August 13, 2004

Serial No.: 04-398
LR/RJG R0
Docket Nos.: 50-336
50-423
License Nos.: DPR-65
NPF-49

DOMINION NUCLEAR CONNECTICUT, INC.
MILLSTONE POWER STATION UNITS 2 AND 3
RESPONSE TO REQUEST FOR ADDITIONAL INFORMATION
LICENSE RENEWAL APPLICATIONS

The following figure replaces Figure F.2-1 of the Environmental Report. LOOP should have been 1.17% instead of 11.7%.

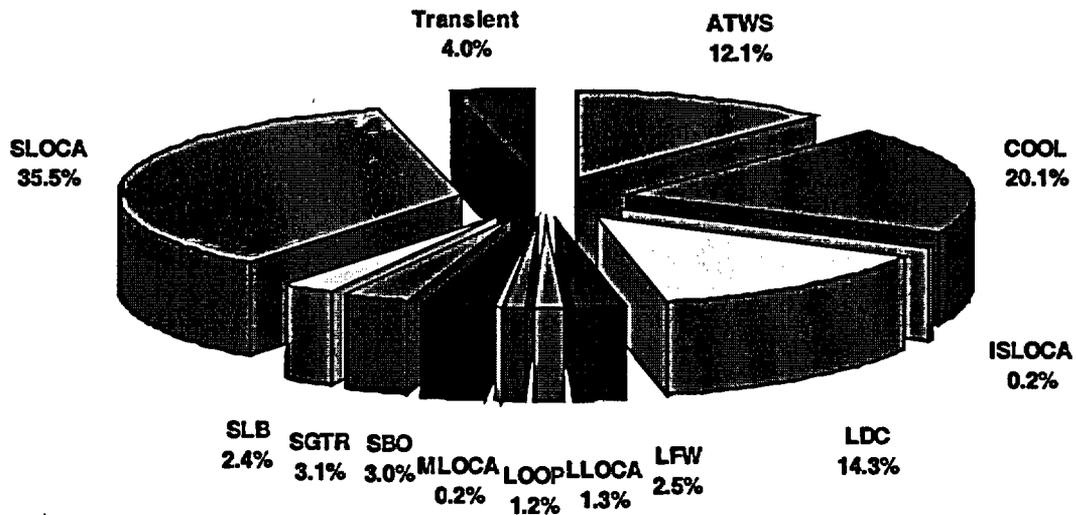
- e. Provide a breakdown of the internal event CDF by accident class, specifically include the contribution from station blackout, anticipated transient without scram (ATWS), and internal flooding.**
